URGENT - Field Safety Notification Medical Device Correction

Philips HeartStart MRx Monitor/Defibrillator on exceptionally rare occasions may exhibit abnormal behavior when operating using a single battery as the sole source of power.

Figure C: AC Module Removal

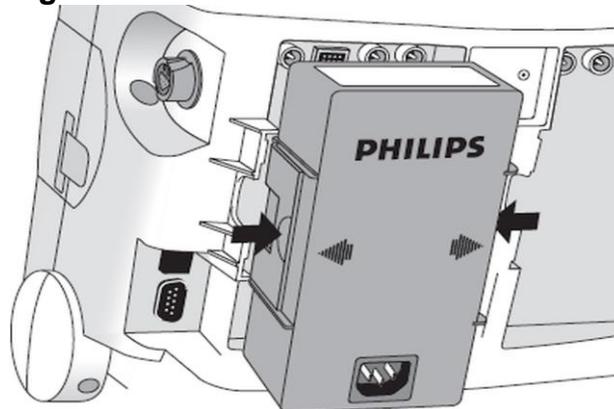
There are two ways to prevent this power switching. The user can either:

- a. Remove the AC module from the MRx, rather than unplugging the cord from AC mains (see Figure C).
